NO.	DESCRIPTION	DATE	APP'D.
2	METAL TRUSS SCOPE REMOVED	02/17/16	
1	TITLE BLOCK REVISIONS

**REPAIRS TO NGIS BUILDING 225
DAM NECK ANNEX**

TRUSS FRAMING PLAN AREA "A"

ROOF PLAN - PLUMBING DEMOLITION
1/16" = 1'-0"

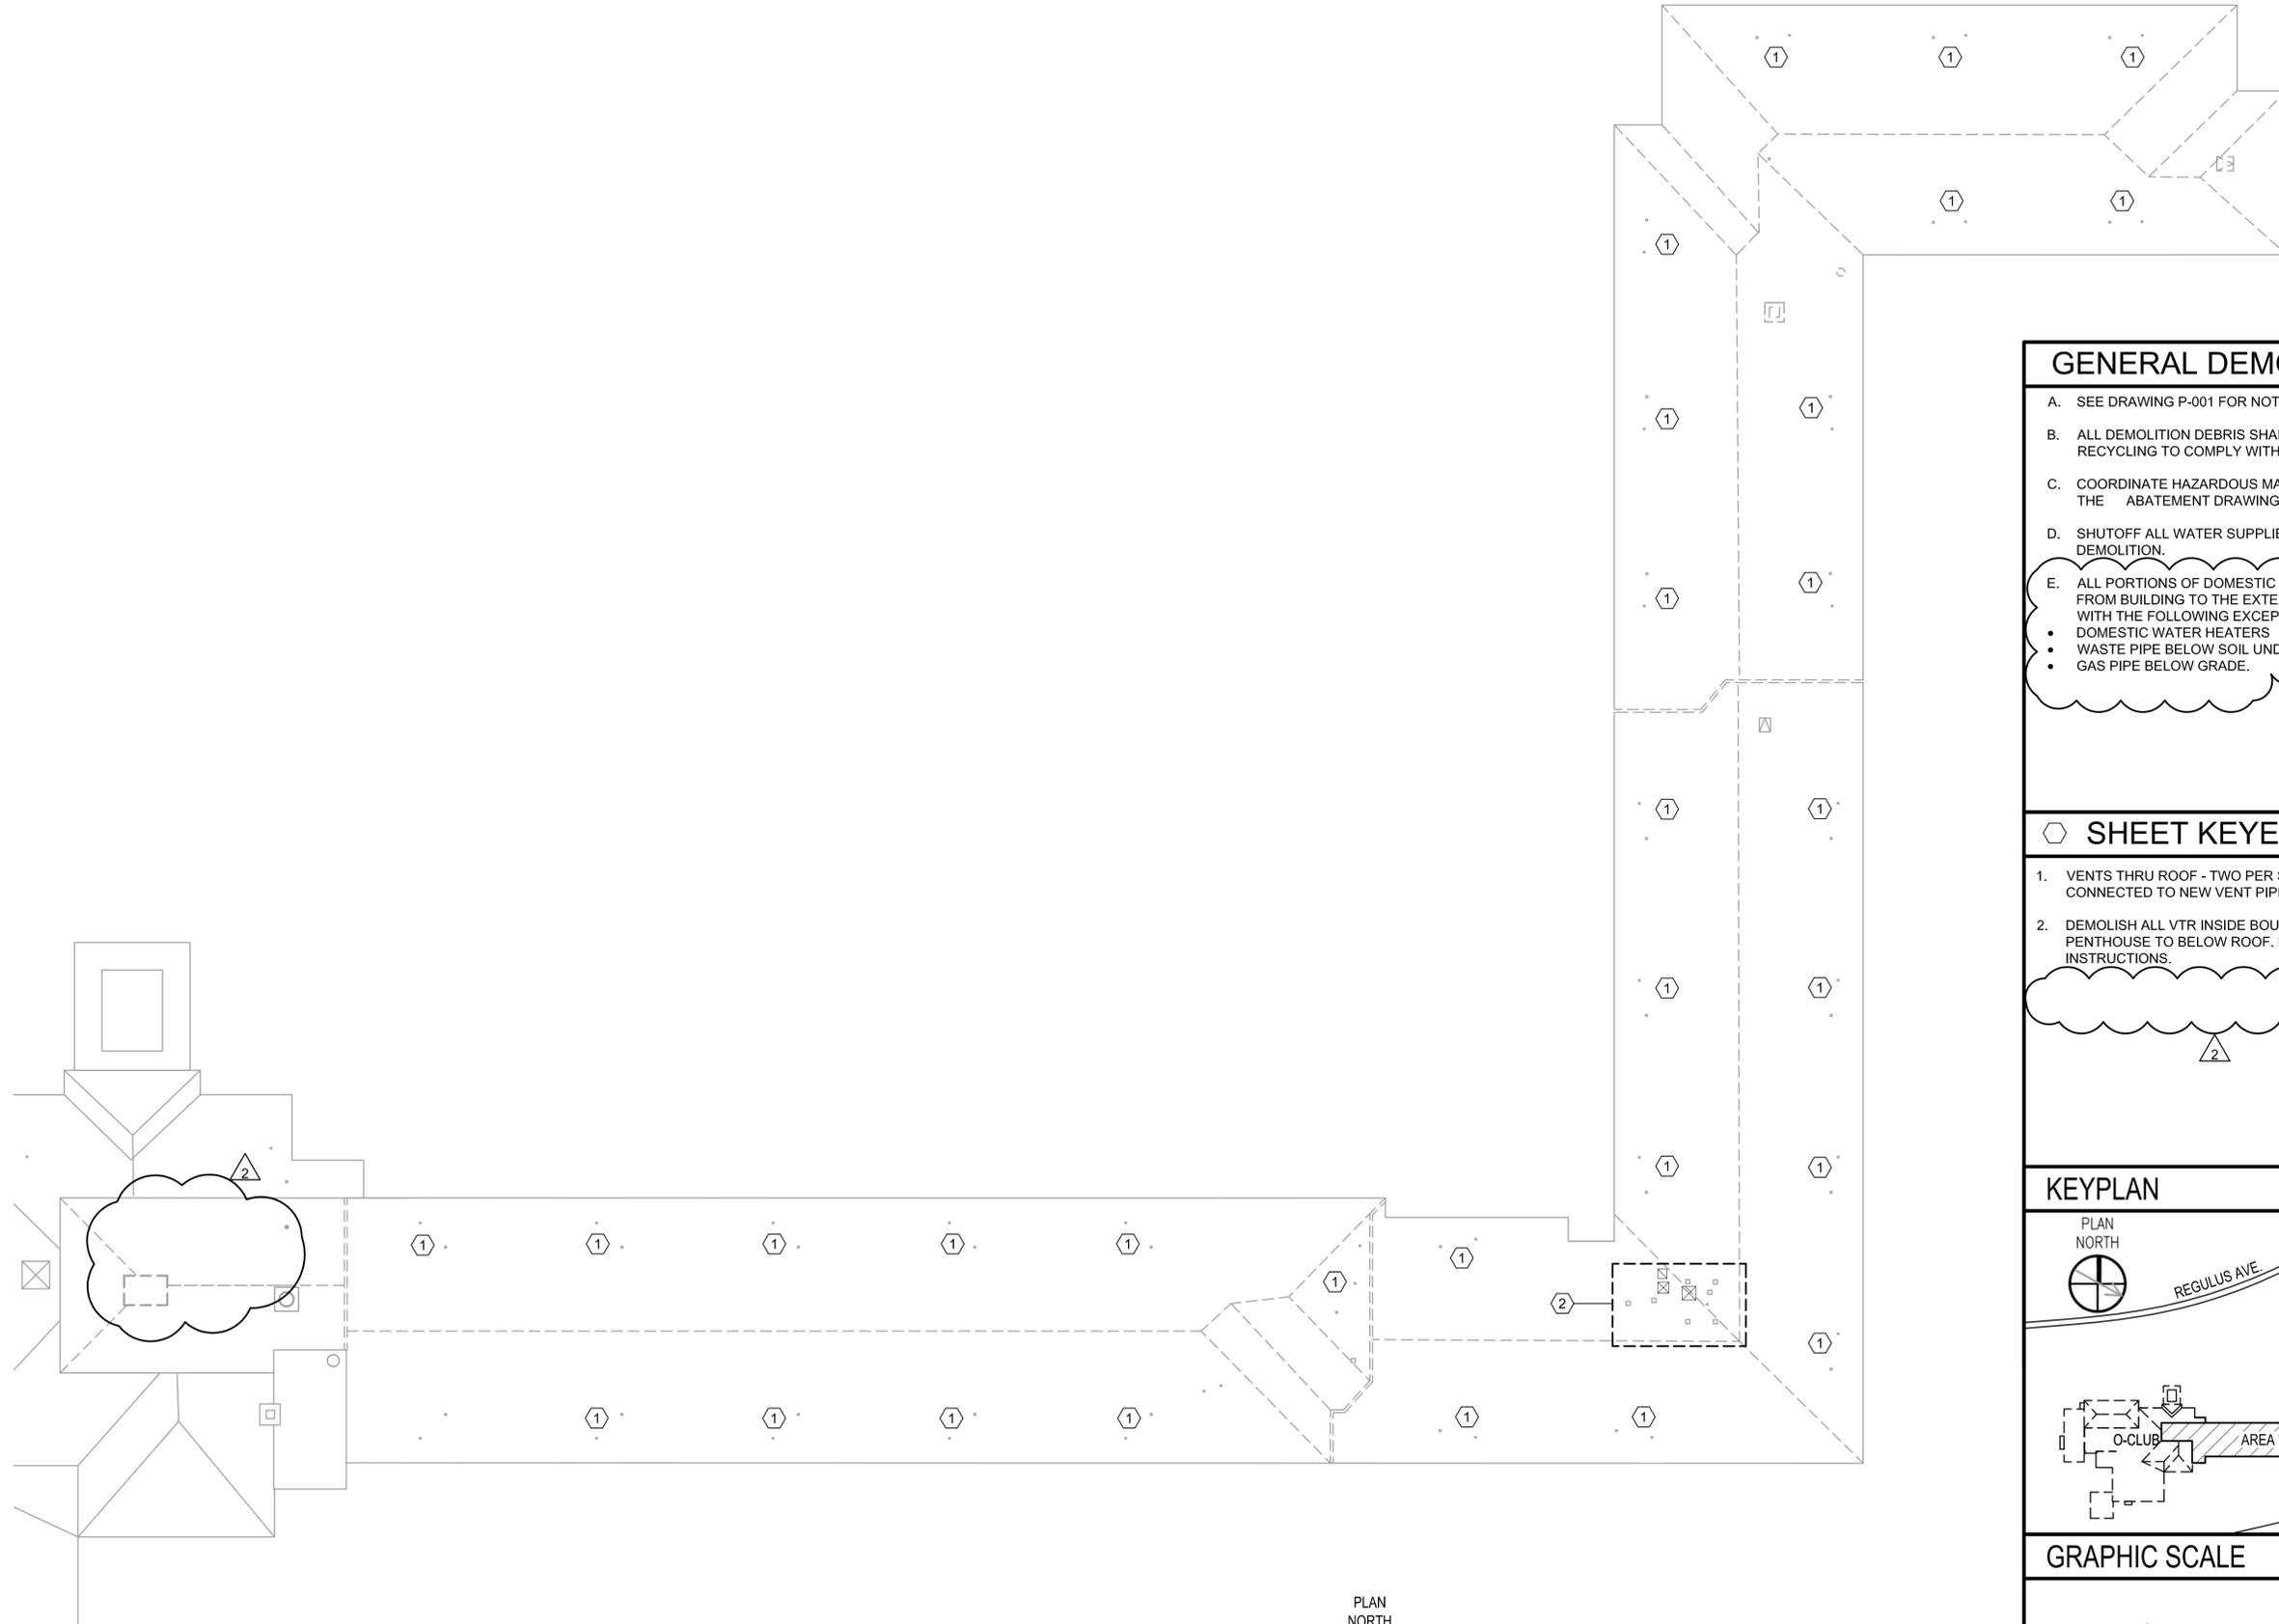
NO.	DESCRIPTION	DATE	APP'D.
2	ROOFTOP UNIT SCOPE REMOVED	02/17/16	
1	TITLE BLOCK REVISIONS

VENT ROOF PLAN
 1/16" = 1'-0"
 PLAN NORTH

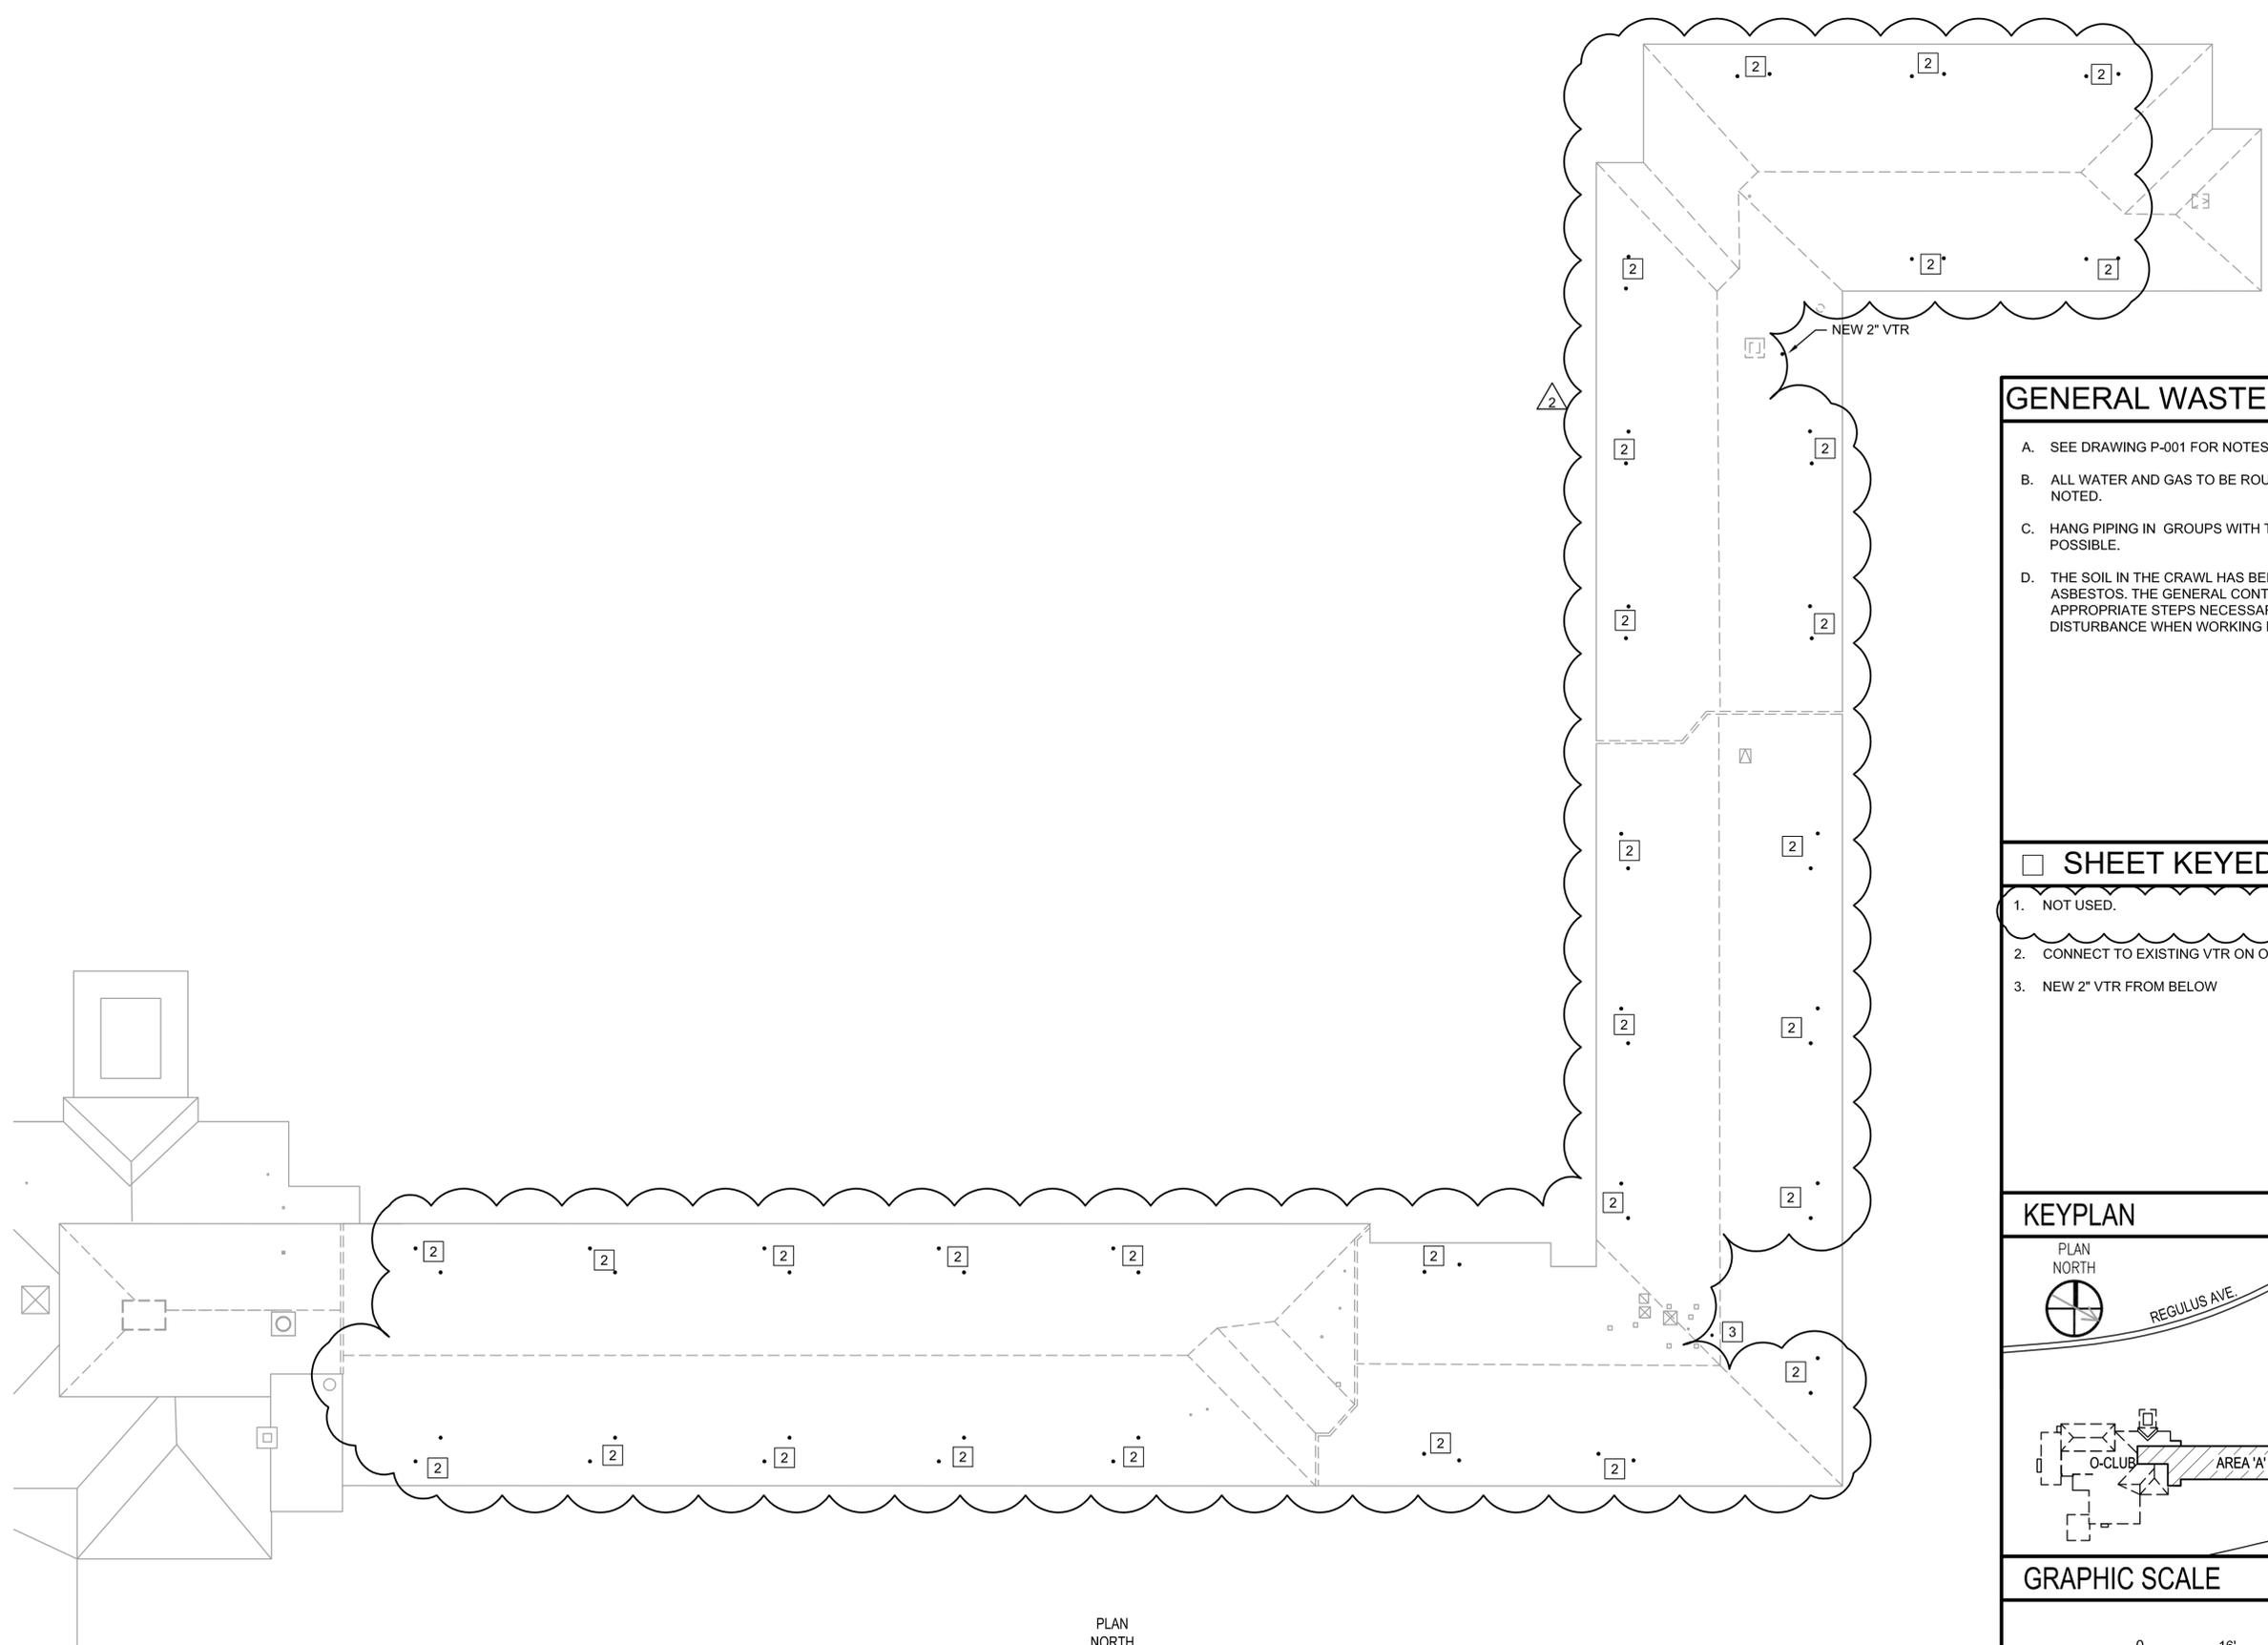
NO.	DATE	DESCRIPTION
2	02/17/16	VENT PIPING MOD REMOVED
1		TITLE BLOCK REVISIONS

ROOF PLAN - HVAC DEMOLITION
1/16" = 1'-0"

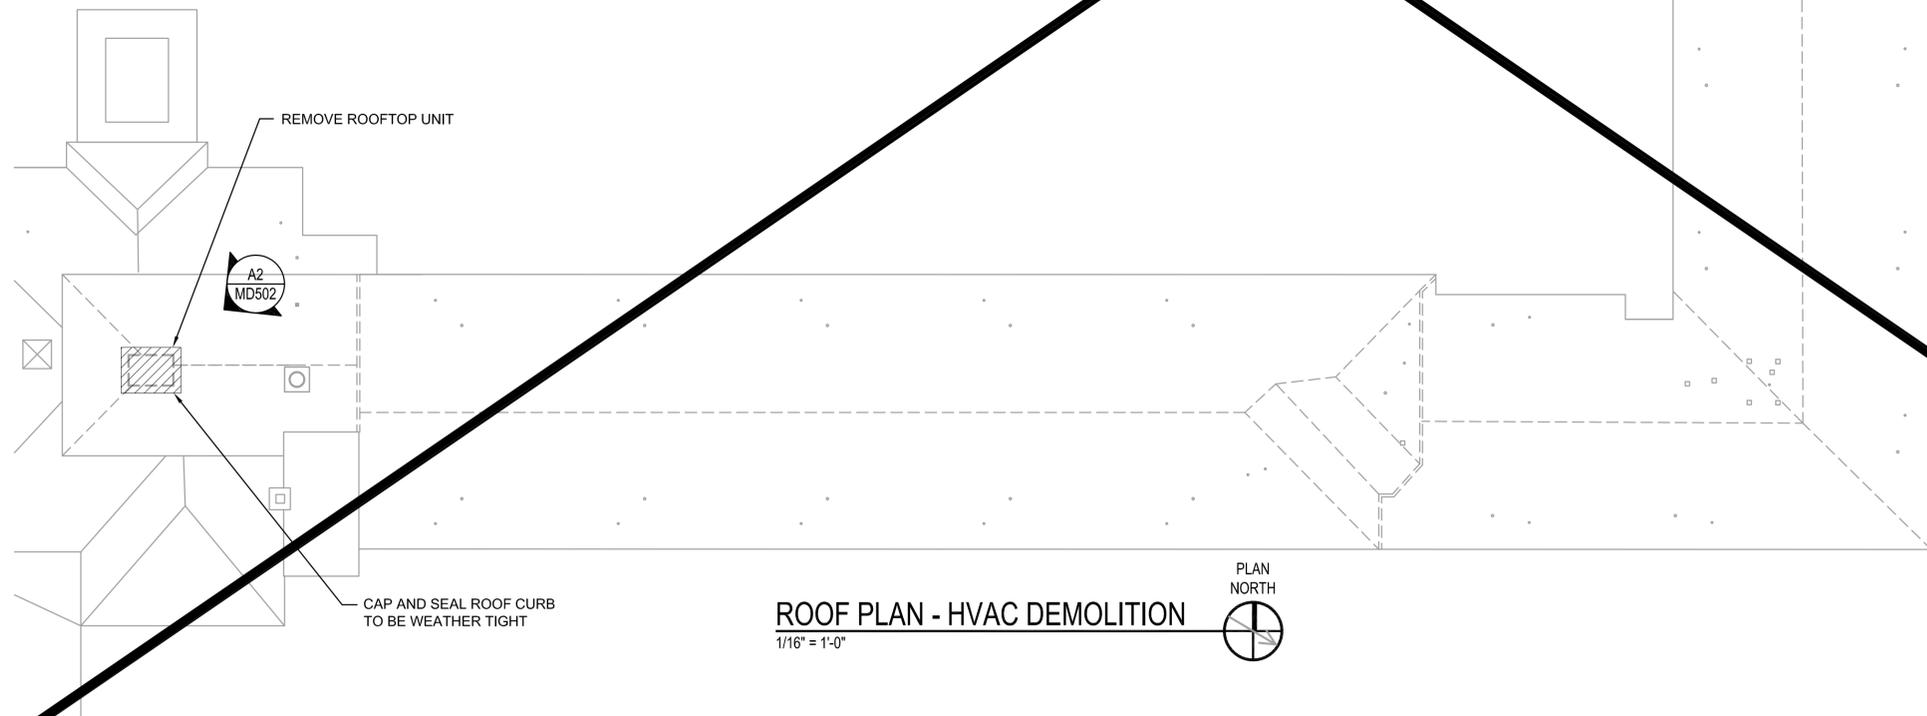
THIS DRAWING NOT IN CONTRACT

NO.	DATE	DESCRIPTION
2	02/17/16	ROOFTOP UNIT SCOPE REMOVED
1		TITLE BLOCK REVISIONS
